CALIFORNIA CROSSROADS

Stage 2 Road Safety Audit

REPORT NUMBER: 70068199/RSA2/1/1

DATE: MARCH 2023

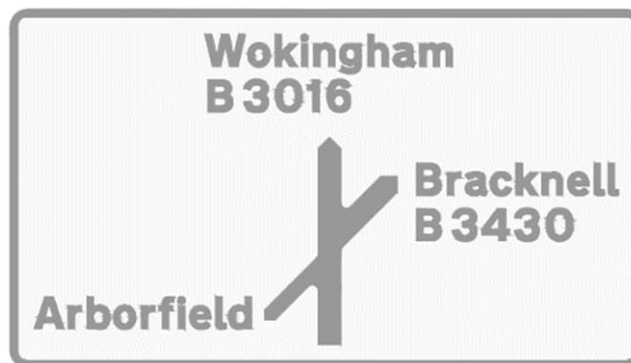
Map-type advance direction traffic signs in the format shown below will be provided on all approaches to the California Crossroads junction. It is considered by the Stage 2 Road Safety Audit Team that these signs could be misleading in relation to the junction layout downstream (i.e. on the sign plate shown below, the thicker lines could imply that straight ahead and right turn movements will have priority at the junction, although the junction layout will not have any movements that have priority over others).

Therefore, this could increase the potential for a road user entering the junction, assuming that they do not need to give-way to other road users, and colliding with another vehicle travelling through the junction. Consequently, it is recommended the proposed map-type advance traffic sign layouts are amended to show an appropriate junction layout design, consistent with the proposed junction layout.

Accepted - A new ADS sign will be added to the proposals for this scheme.

SCALE @ A1:	1:250	DRAWN:	PT	APPROVED:	PT
PROJECT NO:	70088199	DESIGNED:	LS	DATE:	February 23
DRAWING NO:	8199-LA-001	REV:			C03
© WSP UK Ltd

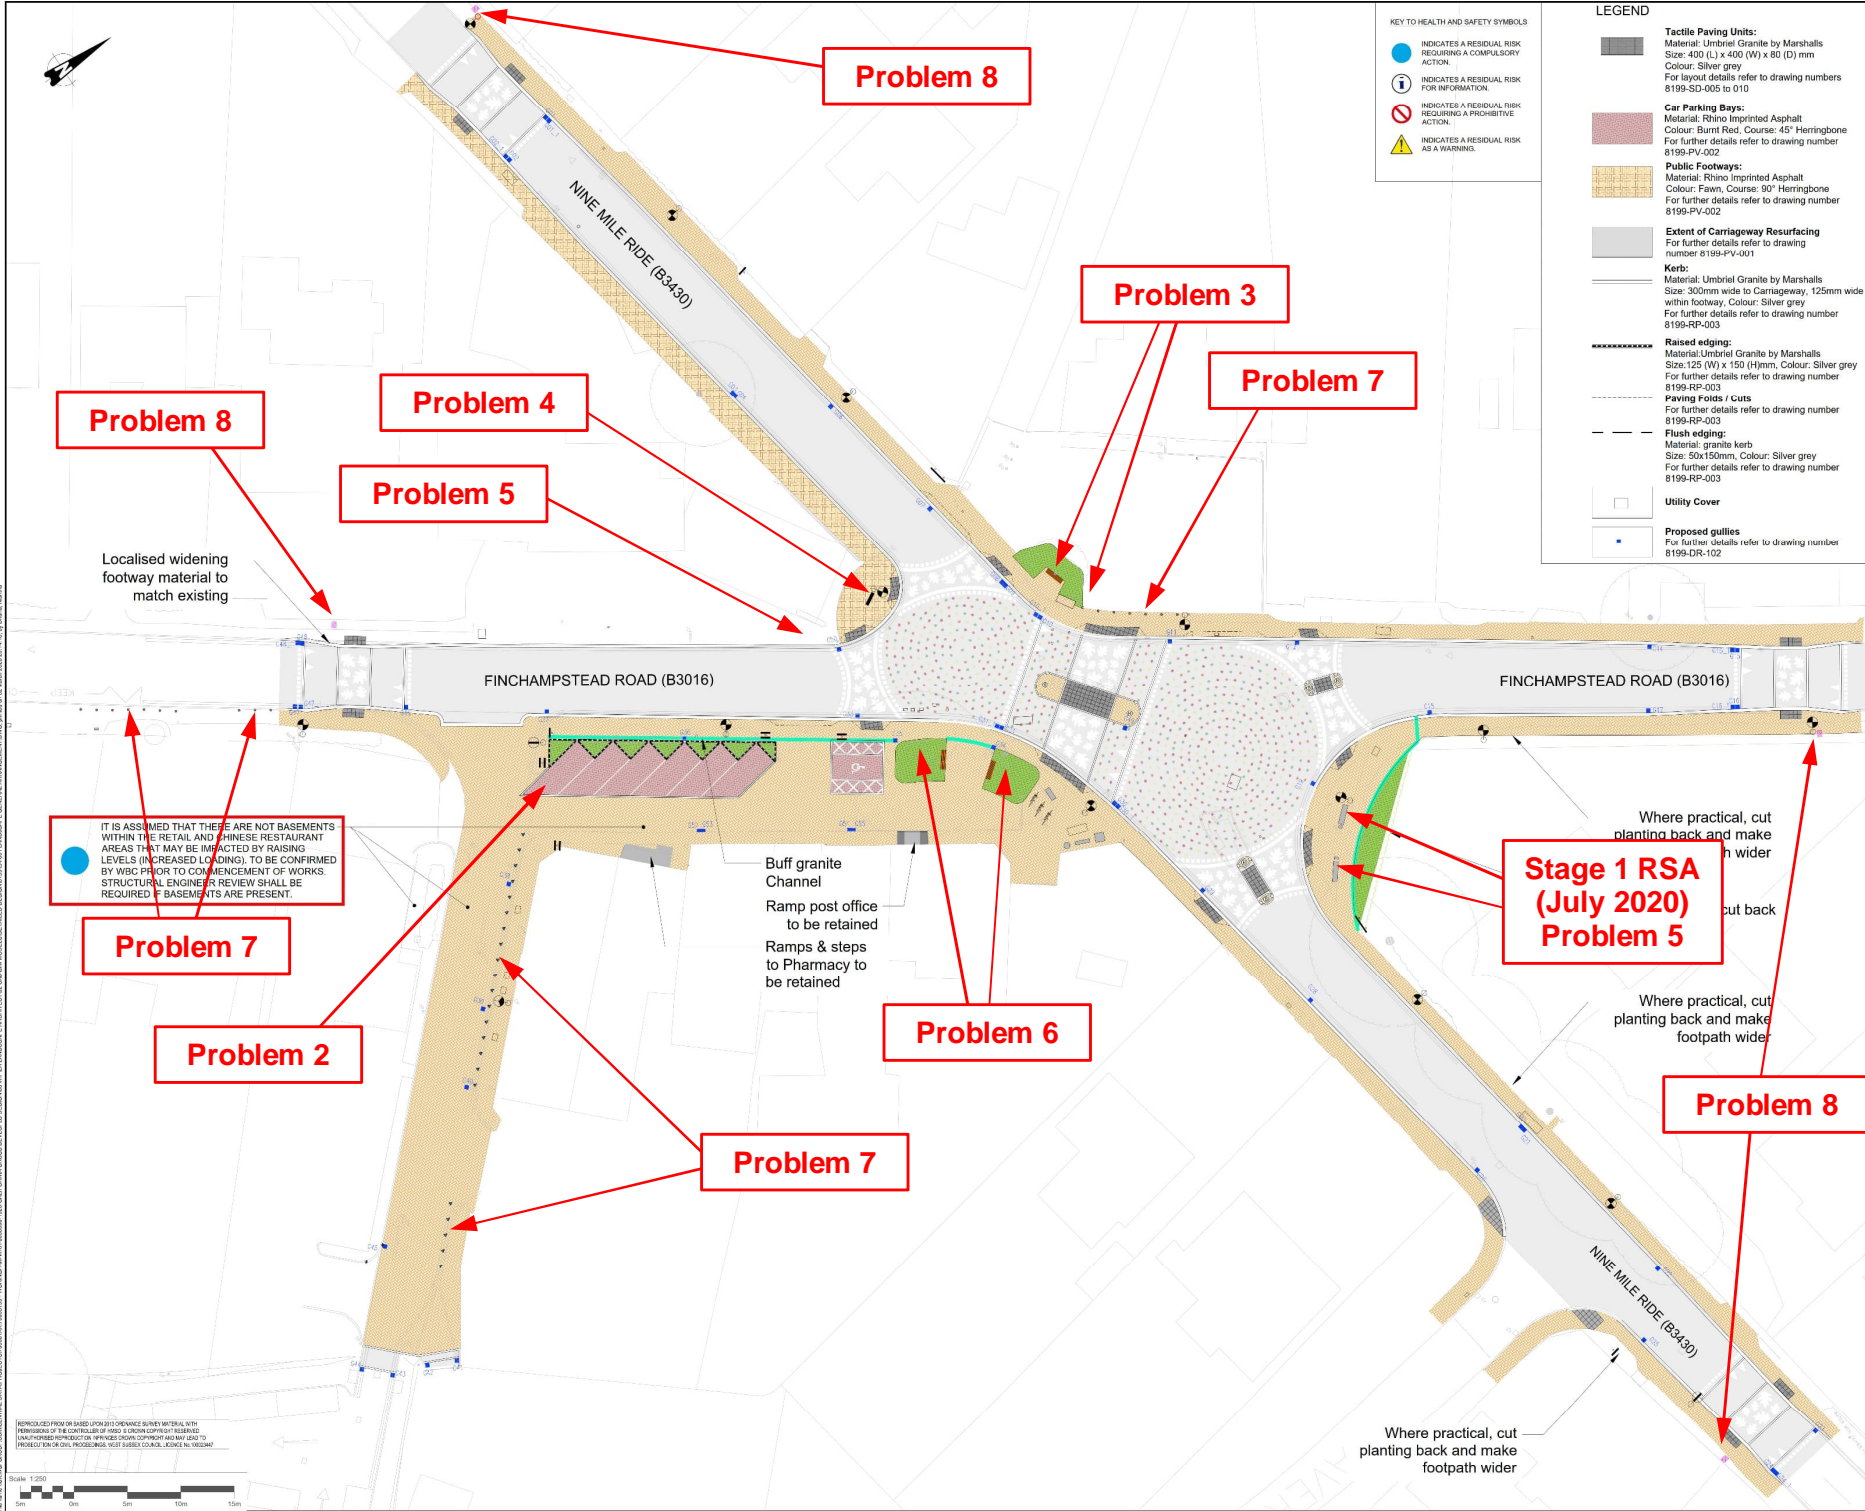
A pedestrian crossing facility will be provided across Finchampstead Road, at the south-western entry of the California Crossroads junction. At the proposed crossing point on the east side of the road, the visibility to the east along Nine Mile Ride could be restricted to approximately 15m by the proposed raised planters and vegetation to be installed adjacent to the crossing point.

It is recommended that the layout / location of the proposed raised planters is amended so that clear adequate visibility of vehicles approaching from the east on Nine Mile Ride is provided from the pedestrian crossing point (located on the east side of the Finchampstead Road south-western arm of the junction).

SCALE @ A1:	1:250	CHECKED:	MFB	APPROVED:	SD
PROJECT NO:	70068199	DESIGNED: <td>YO</td> <td>DRAWN: <td>YO</td> </td>	YO	DRAWN: <td>YO</td>	YO
DRAWING NO:	8199-TS-002	DATE:	July 22	REV:	P02

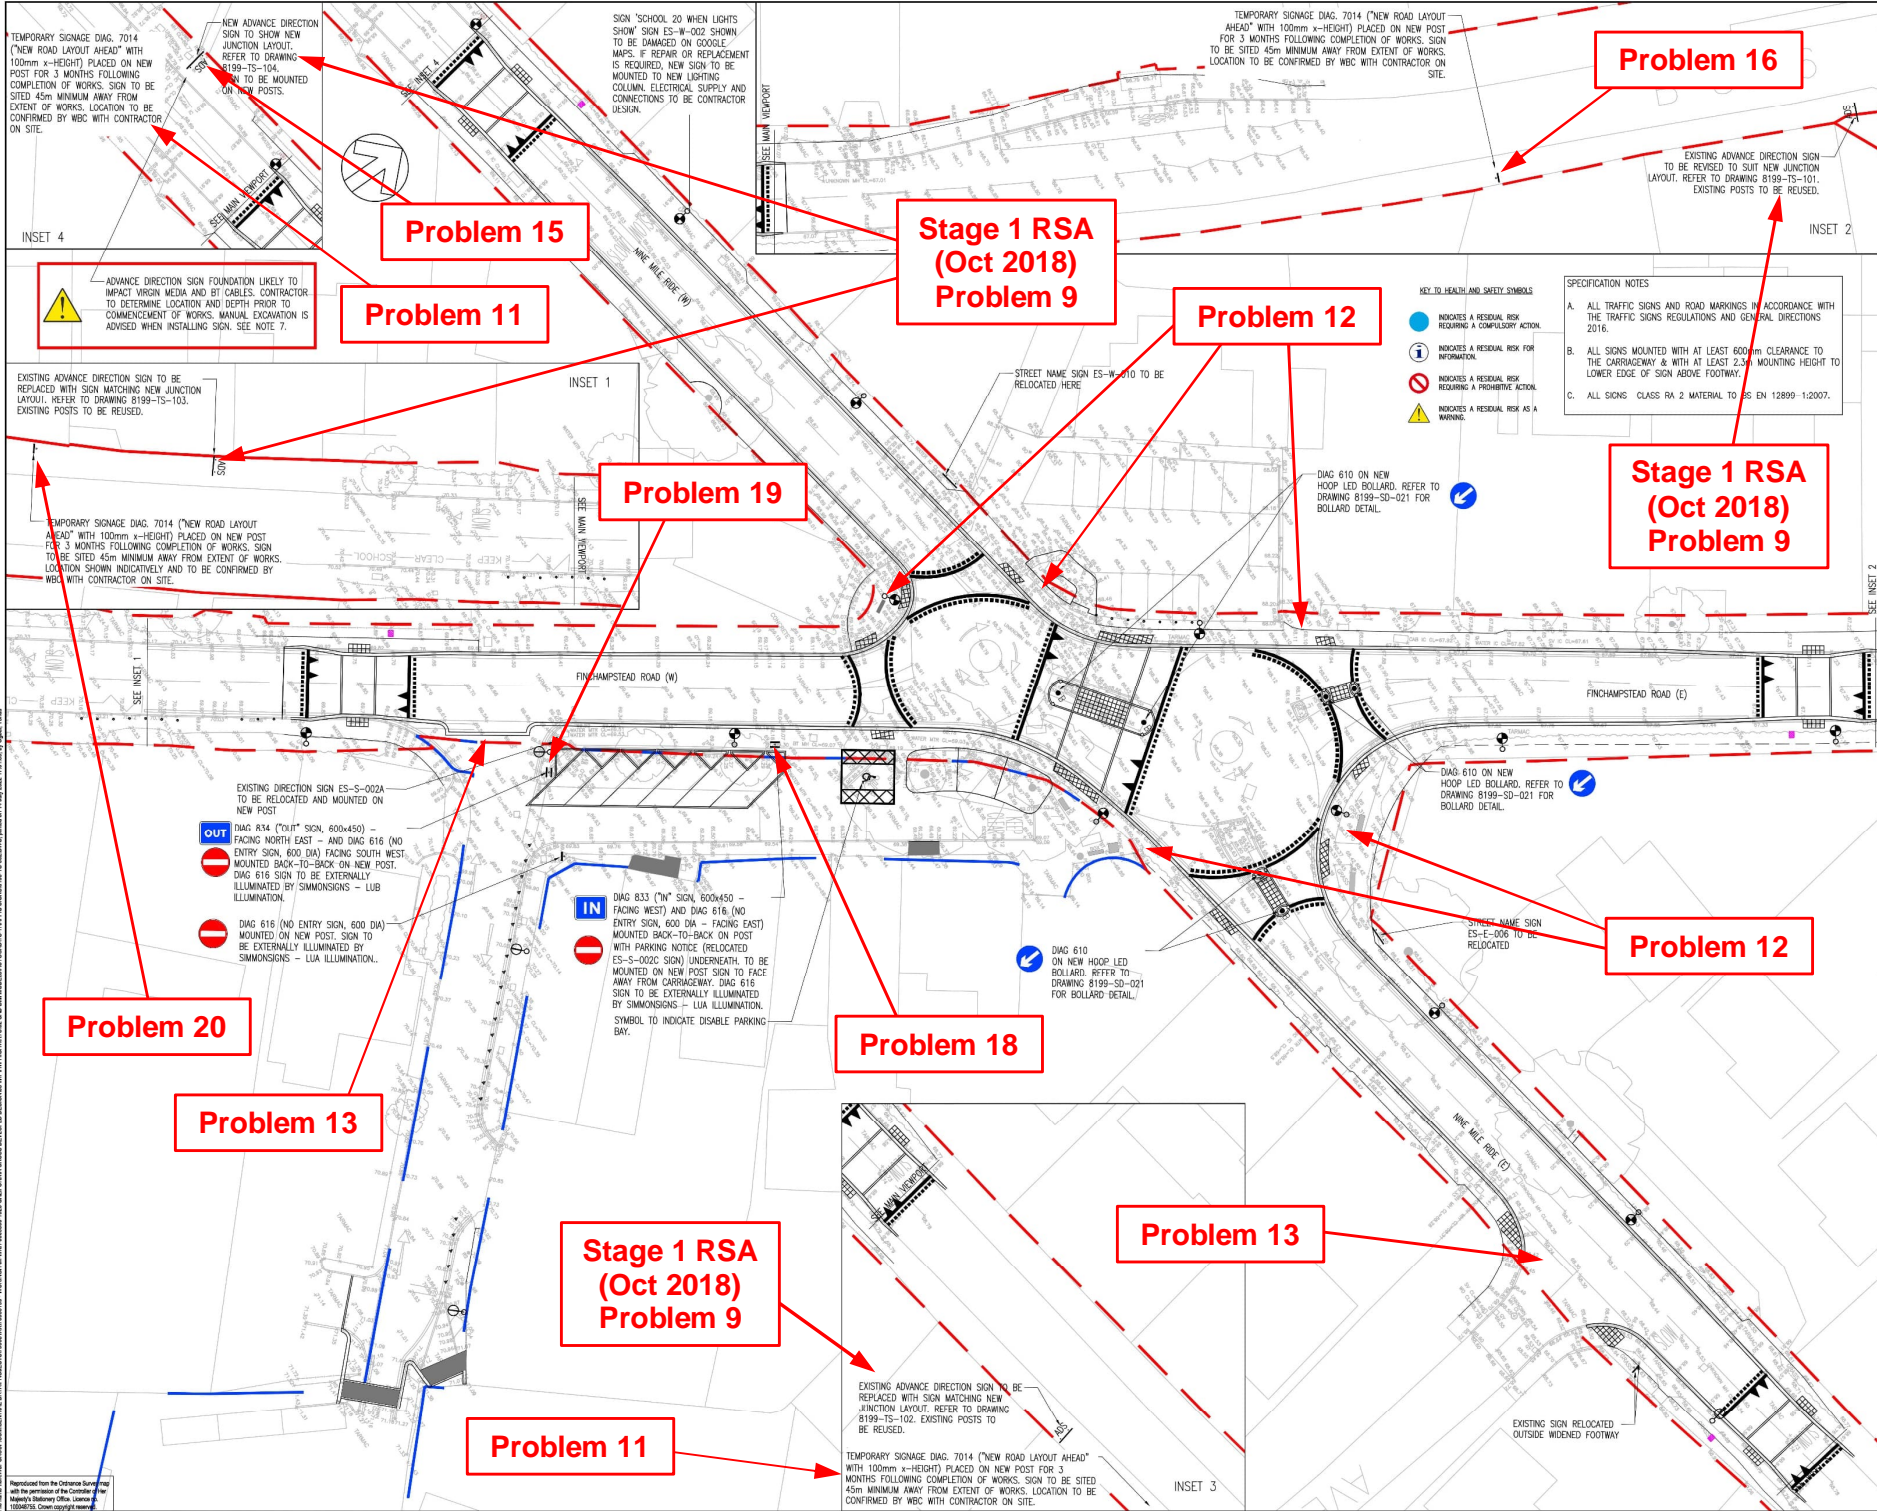
The exact locations of the proposed “New Road Layout Ahead” traffic signs, on the Nine Mile Ride westbound and eastbound approaches to the junction, are unclear from the design drawings (drawing number 8199-TS-002 states that these signs will be installed a minimum of 45m upstream of the scheme extents). These signs could be installed on new sign posts in the centre of the footways, where they will present an obstruction to pedestrians, or they could restrict the visibility of existing traffic signs located adjacent to the proposed signs.

SCALE @ A1:	1:250	CHECKED:	JHR	APPROVED:	SD
PROJECT NO:	70068199	DESIGNED:	YO	DATE:	September 2021
DRAWING NO:	8199-RP-003	REV:			
© WSP UK Ltd

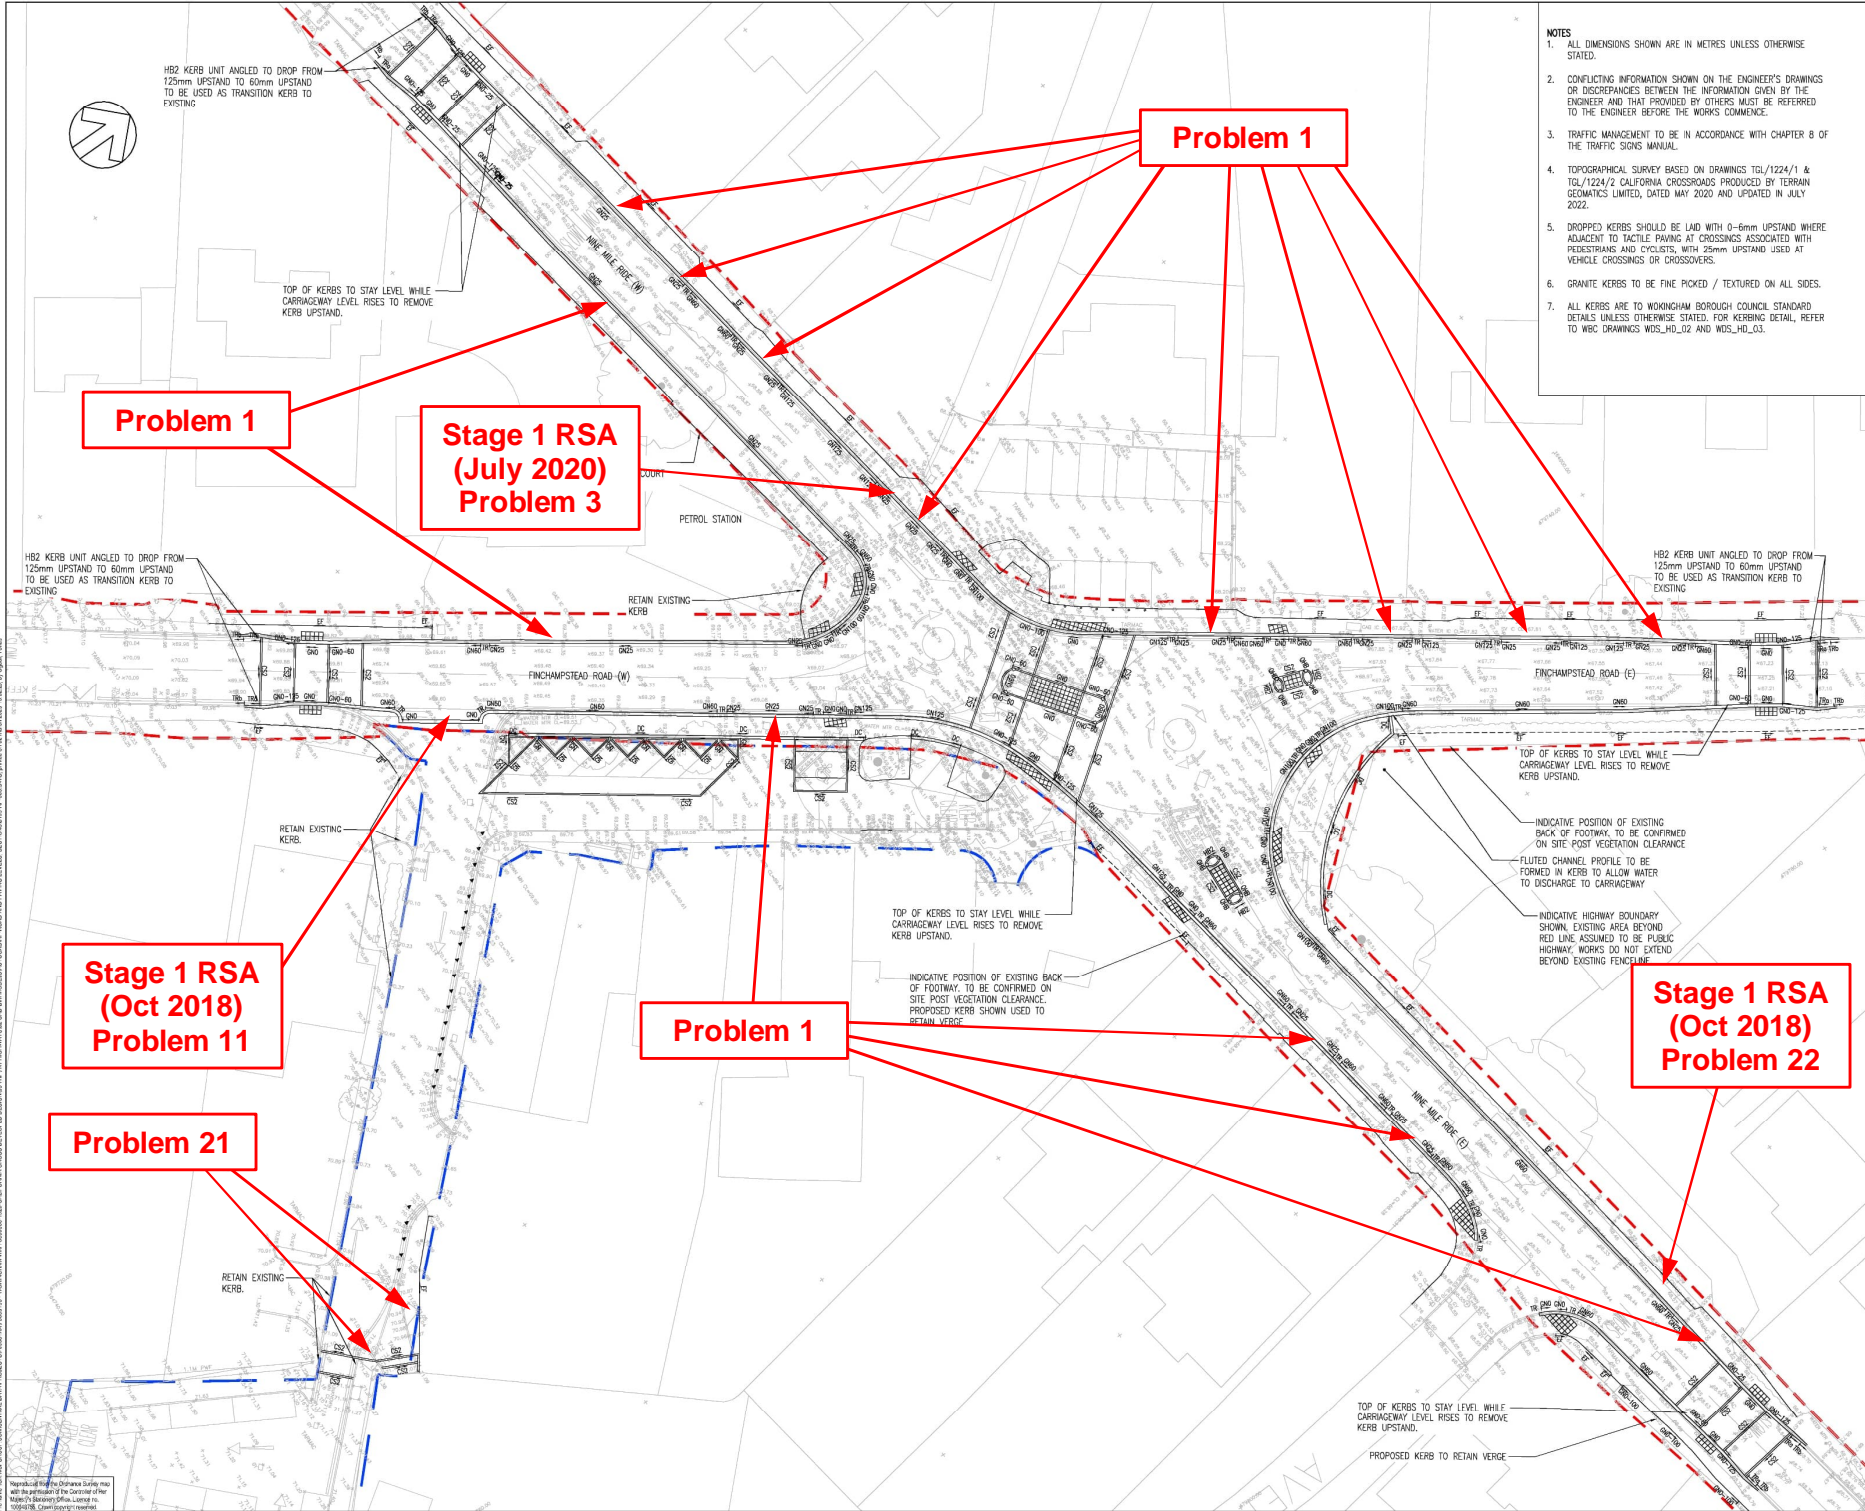
Drawing number 8199-RP-003 (revision P02) shows that no raised access kerbs are proposed at the existing eastbound bus stop on Nine Mile Ride, adjacent to the junction with Avery Close. Therefore, the problem / recommendation made at the Stage 1 Road Safety Audit remains relevant.

Drawing number 8199-RP-003 (revision P02) shows that the proposed kerbing throughout the extents of the scheme will primarily be provided with 25mm or 60mm upstands adjacent to the carriageway. Therefore, the problem / recommendation made at the Stage 1 Road Safety Audit remains relevant.

Drawing number 8199-RP-003 (revision P02) shows that dropped kerbs with a 25mm upstand will be provided at the western entrance into the Red Oak Stores access. However, the length of these dropped kerbs does not cover where the swept path of a large articulated vehicle will turn left into the car park access from Nine Mile Ride (as shown on drawing number 8199-ATR-002). Therefore, this problem and recommendation remains relevant.
